A G E N D A

Architectural Review Board

April 26, 2016

PLANNING CONTROLS DIVISION

303 Felder Avenue

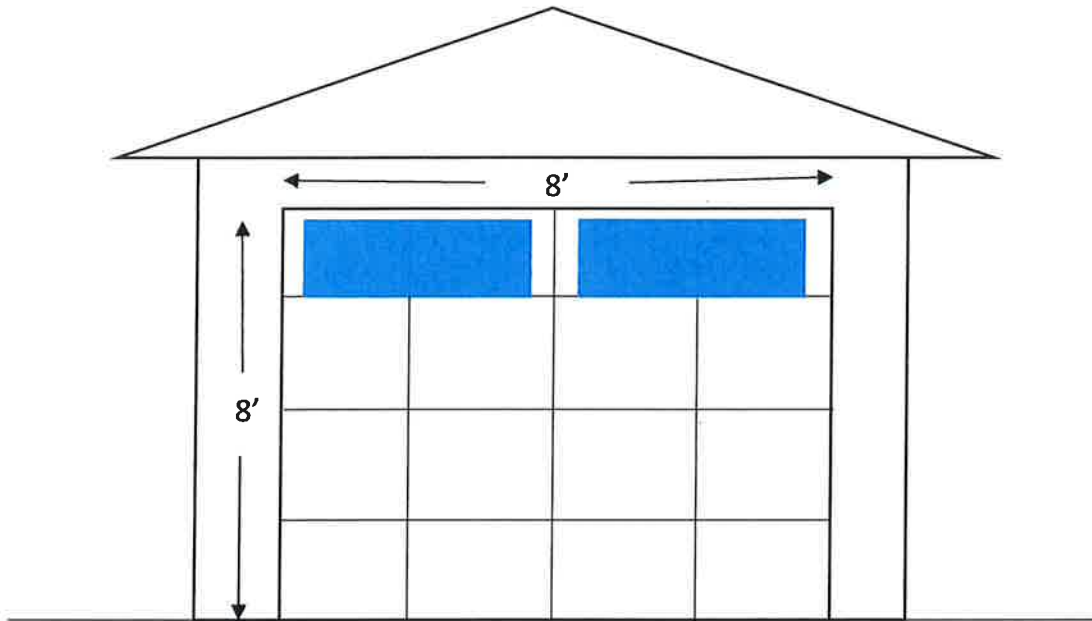
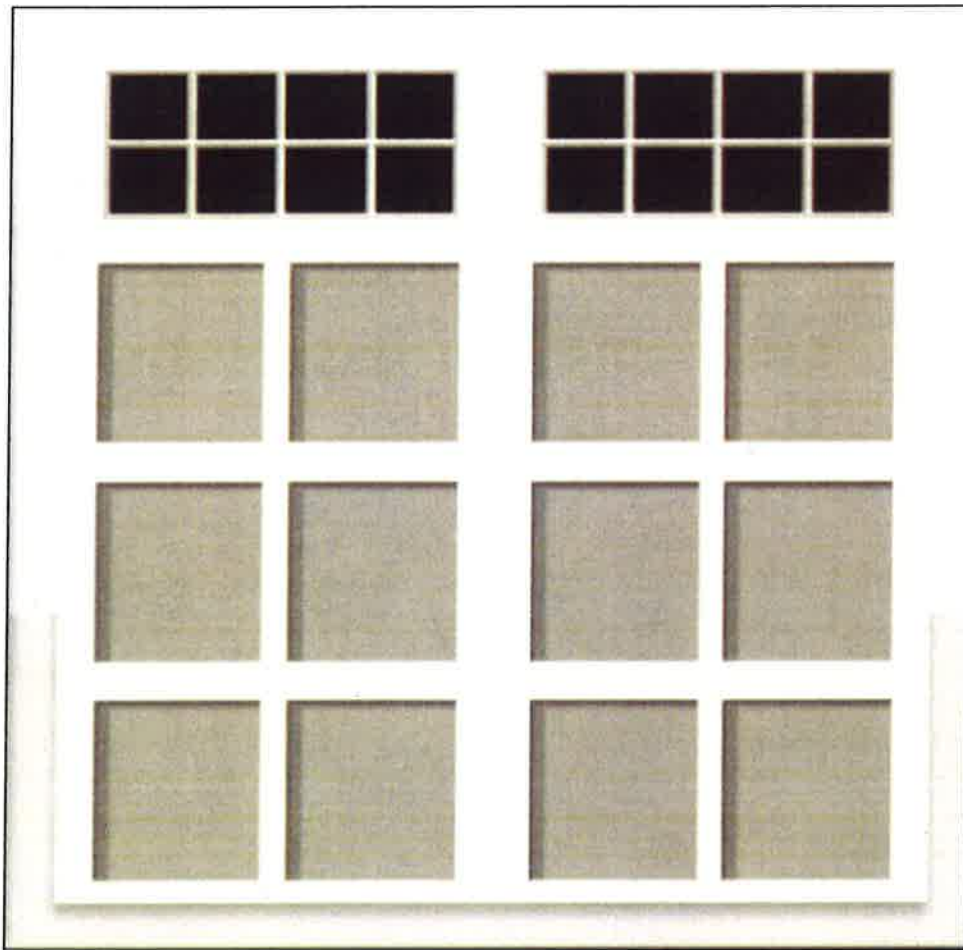
REMARKS: The petitioner is requesting permission replace the current garage door with a manufactured steel insulated door. The current wood door has rotted and the rails shifted, and the locking mechanism can no longer be engaged. The proposed door will be similar in configuration to the current door (see image), and use opaque glass. The door will be painted the pre-approved palette gray (400-22) with white.

- The Board has previously approved steel garage doors that were good matches to the historic door it replaced or a good stylistic match with the house.

3370 Lexington Road

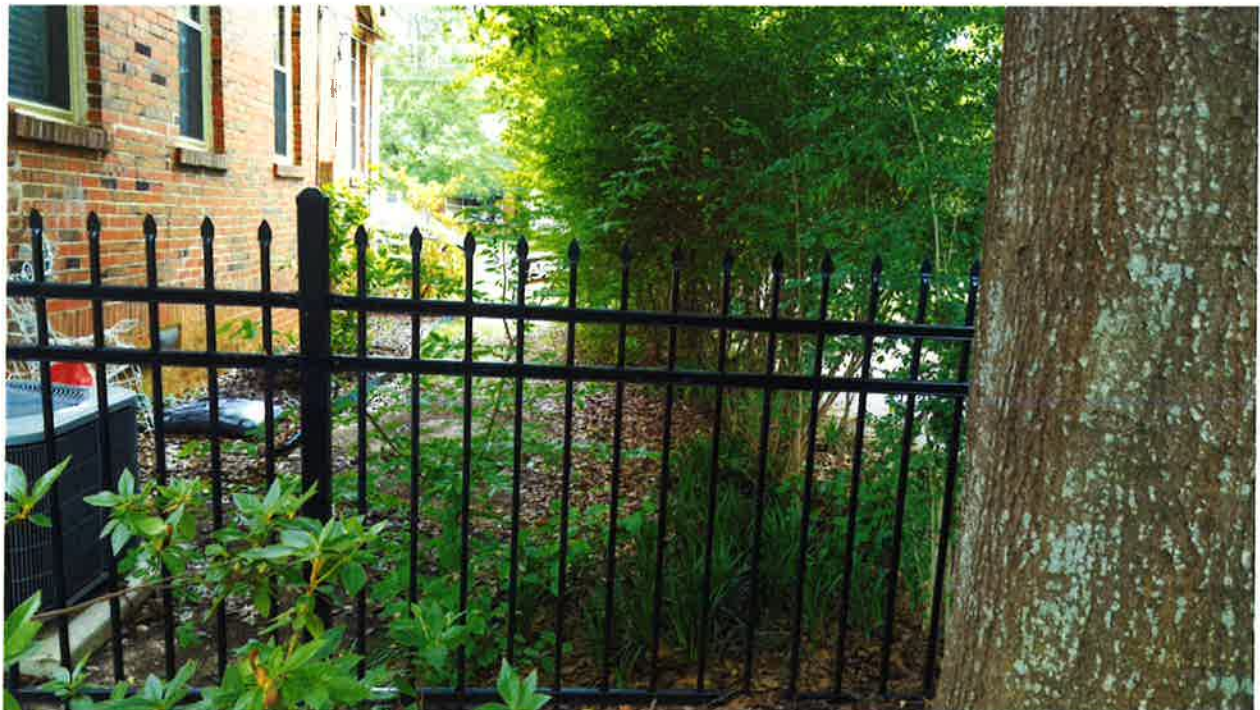
REMARKS: The petitioner is requesting permission to install a 32” high ornamental iron rail around the porch, as well as handrails at the front steps. All metal will be finished in satin black enamel. There is an approximately 2 foot drop off the porch, which is a potential hazard for a small child. The proposed rail will match an existing gate and fence already on the property (previously approved by the Board), with a flat top handrail in place of the finialed pickets. Examples of other similarly configured porches with metal railings in the neighborhood are also included.

- Metal porch rails have been approved, particularly in locations where a more inconspicuous railing is more appropriate than a heavier wood balustrade.

407 East Fairview Avenue

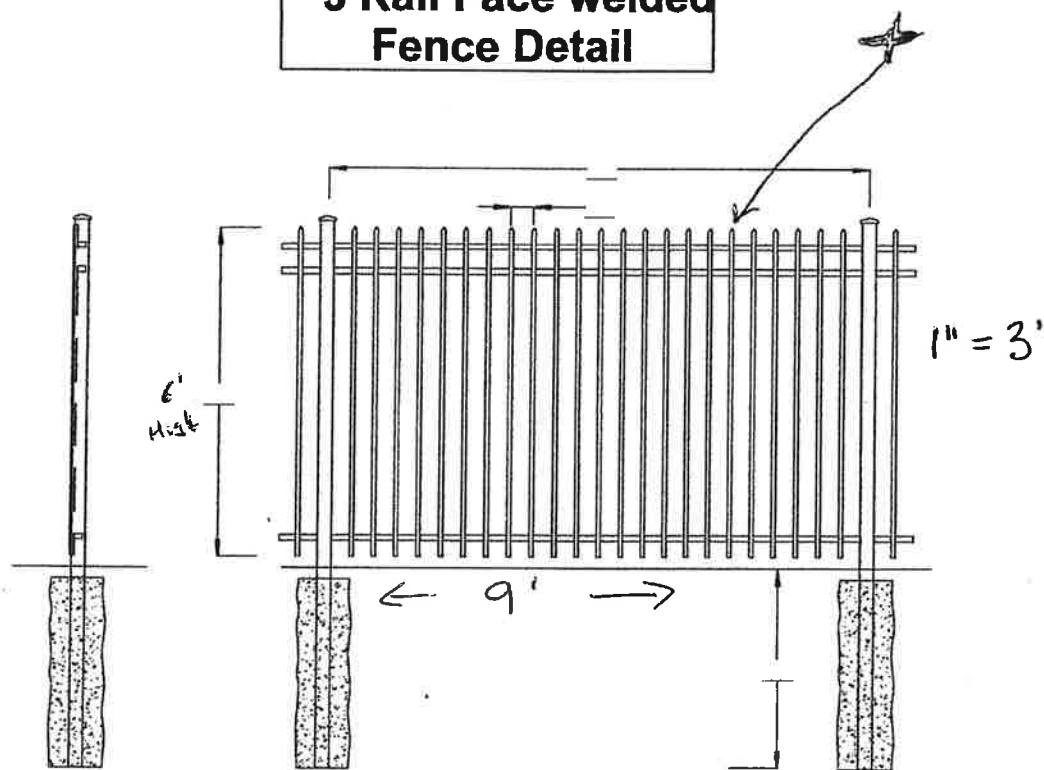
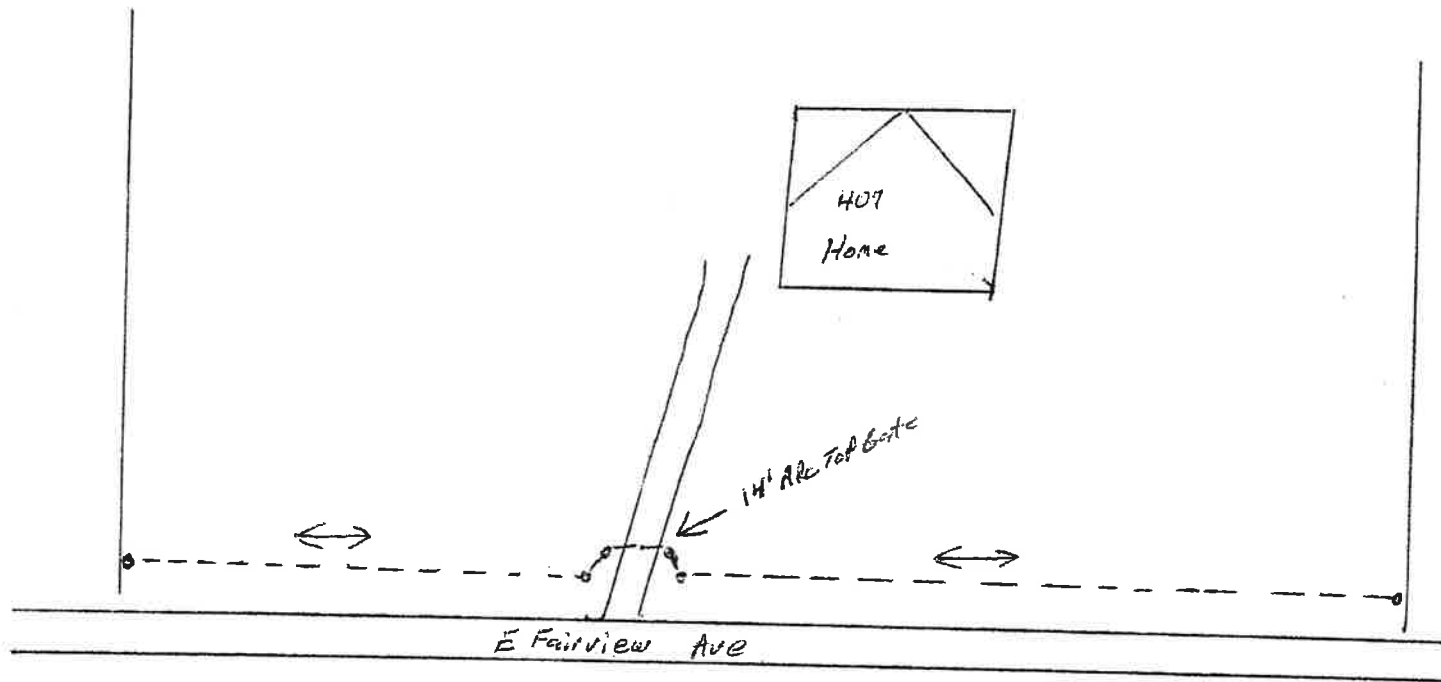
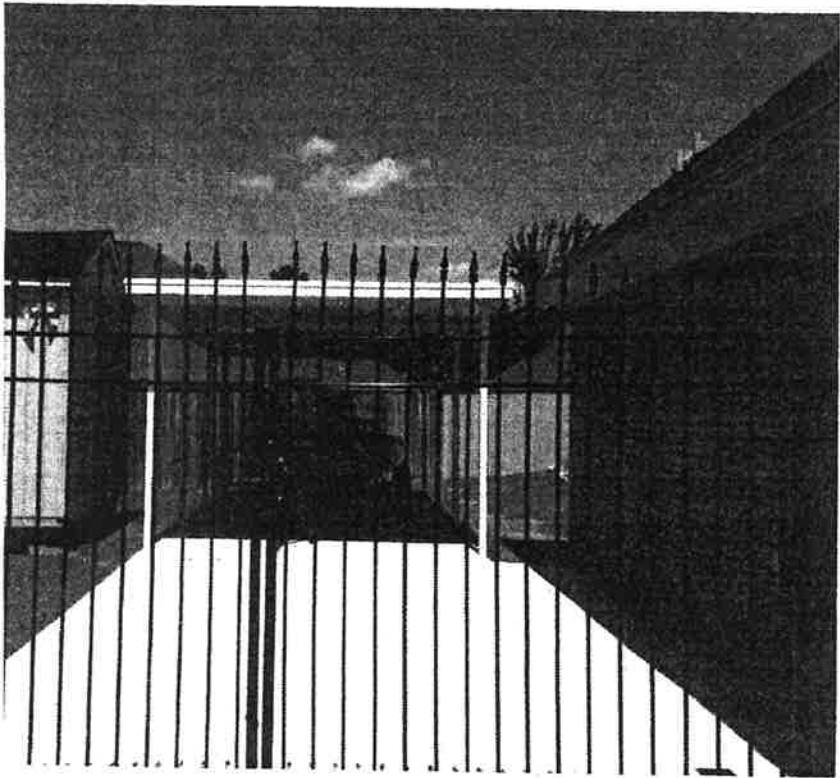
REMARKS: The petitioner is requesting permission to install a 6' high ornamental iron fence at the front property line, with a 14' wide driveway gate with an arch top.

- The Board has generally approved front yard fences under 4'. Front yard fences in neighborhoods were intended to create separation from public space, but allow you to engage your neighbors over the fence, not through the fence.
- This house is situated on an "estate" lot and has a different relationship to the street, and there is no sidewalk on Fairview Avenue. The Board should consider if the proposed fence is appropriate to the style of house and setting.
- As the petition does not specify whether the fence will be in front of or behind the existing vegetative screen, the Board may also consider specifying the fence be installed behind the existing, mature vegetation that covers a portion of the front of the lot.

1201 Woodward Avenue

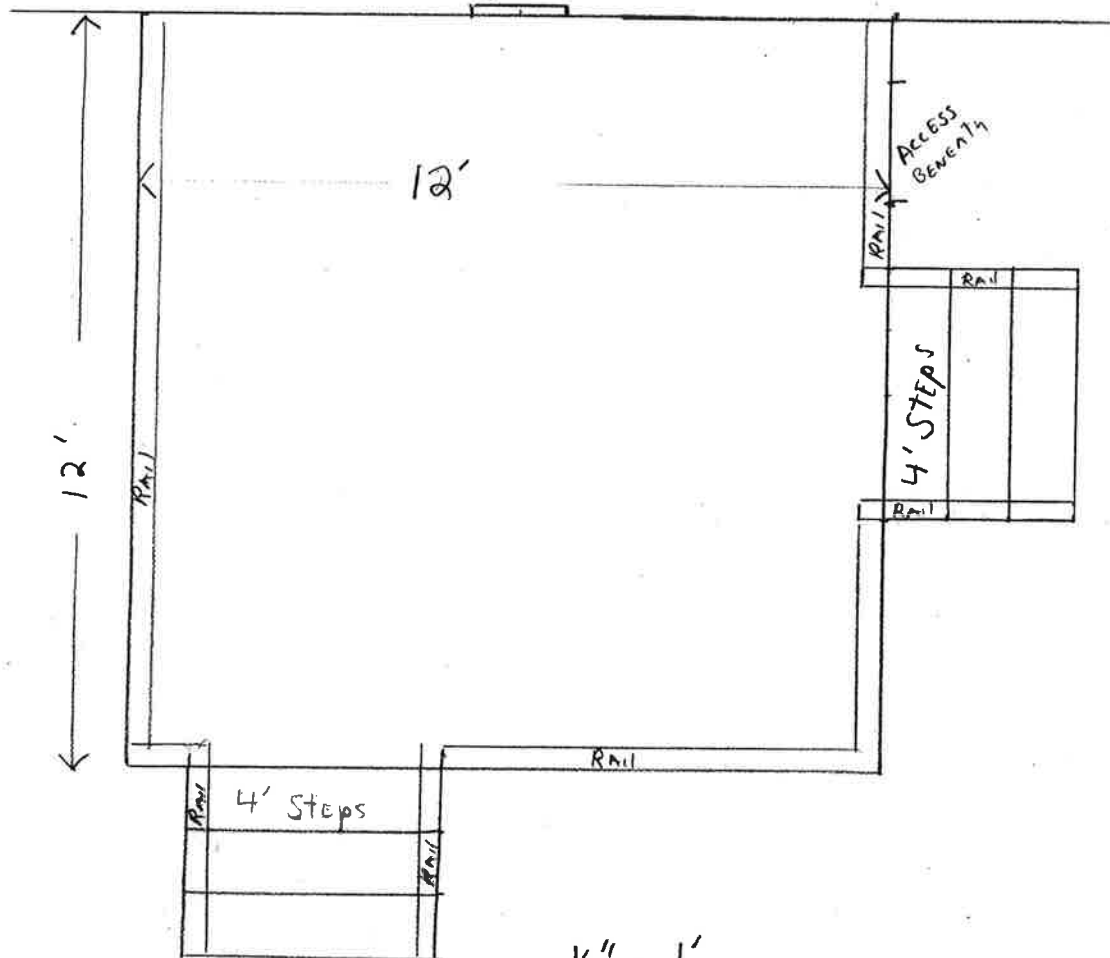
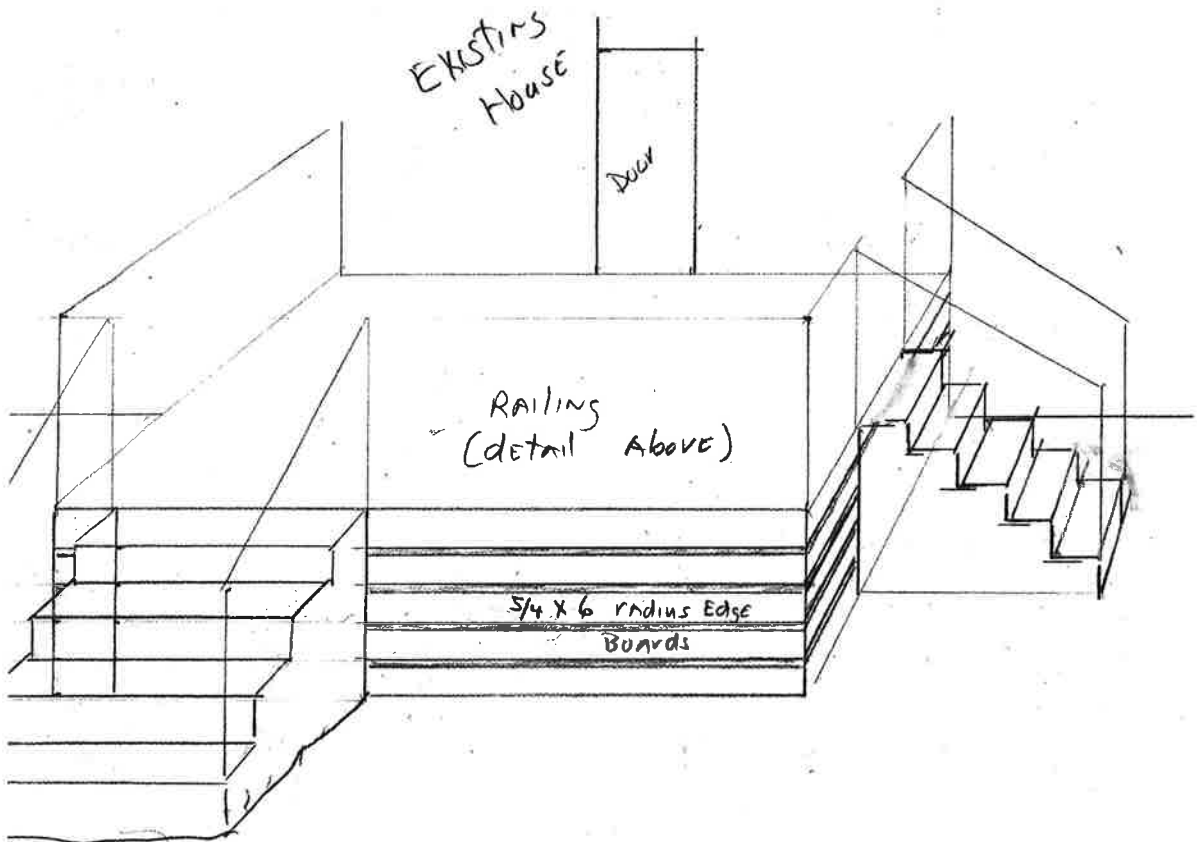
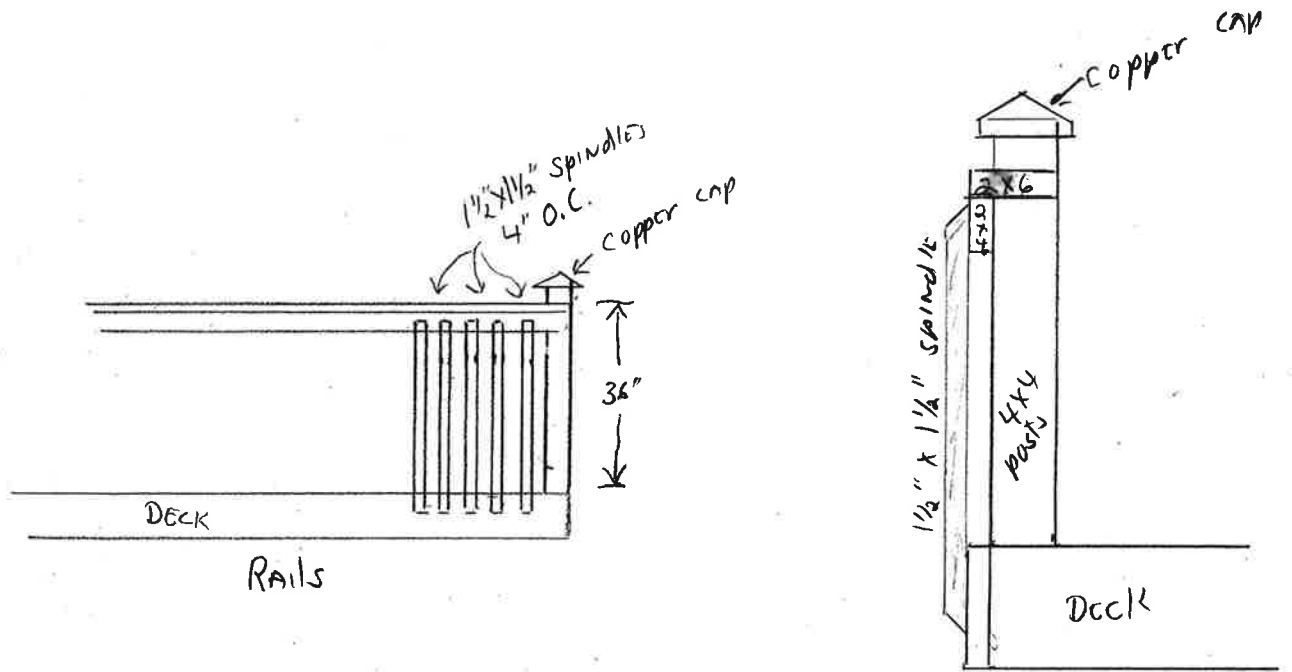
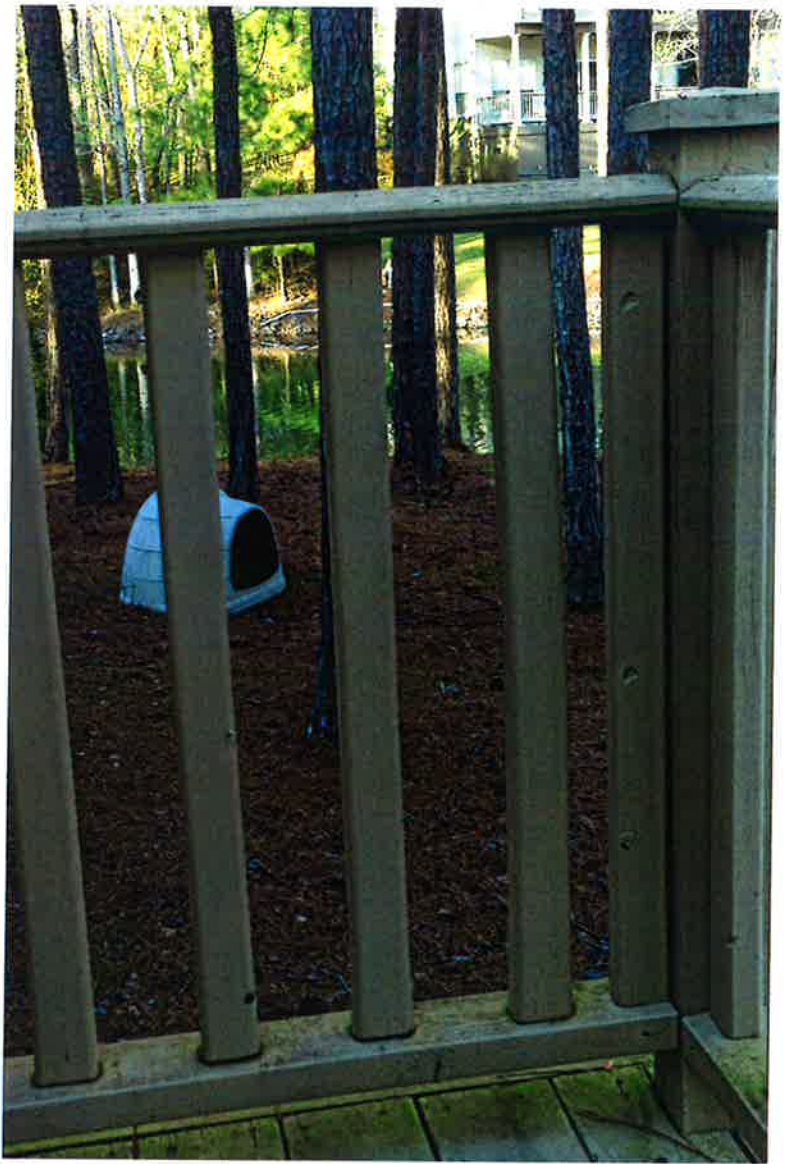
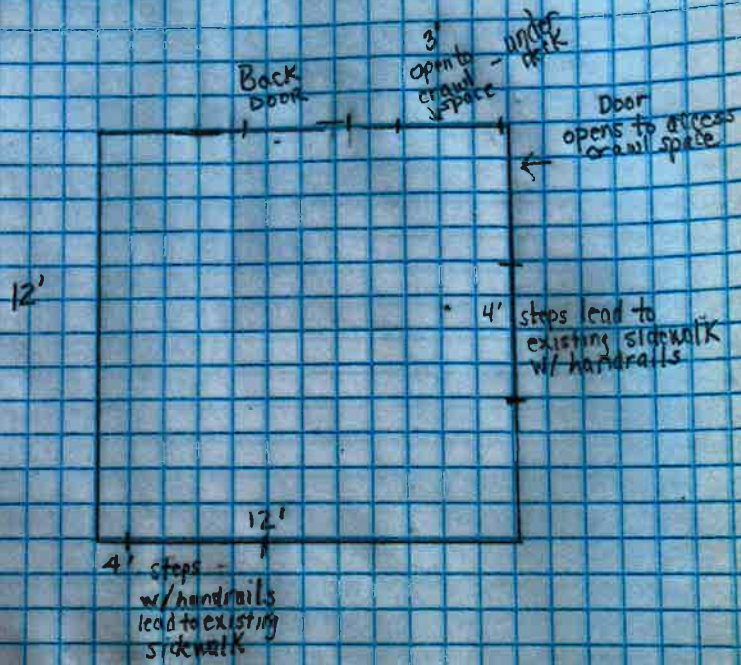
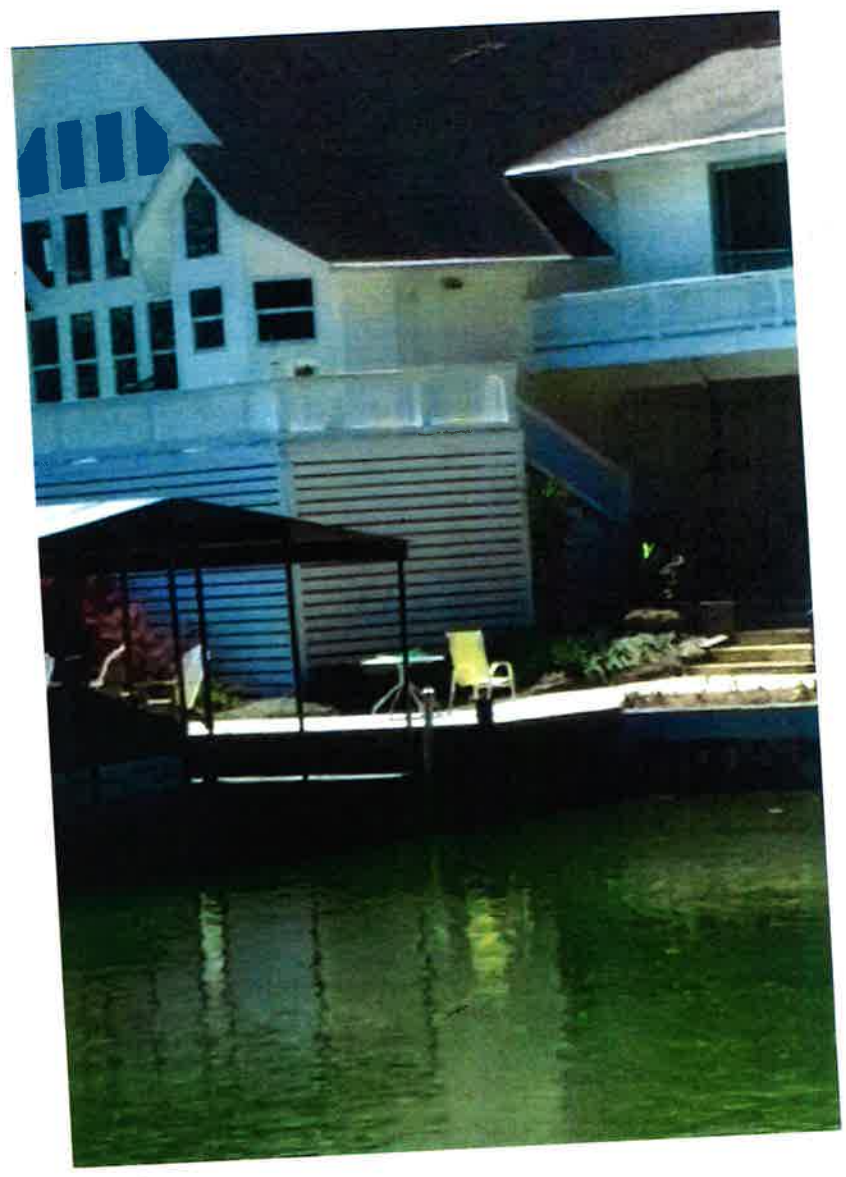
REMARKS: The petitioner is requesting permission to construct a 12x12 deck off the rear of the house. The deck will have a railing and a horizontal 5/4 deck board skirting, with 2 stairs leading to existing sidewalks. The deck will be stained in "Gray Seas" (sample will be provided at the meeting), which is similar to the color of the house.

- This is a corner lot, the deck will be visible from Girard Street.
- The Board has approved horizontal deck skirting on previous requests. The 5/4 board will hold up longer than a lattice panel.
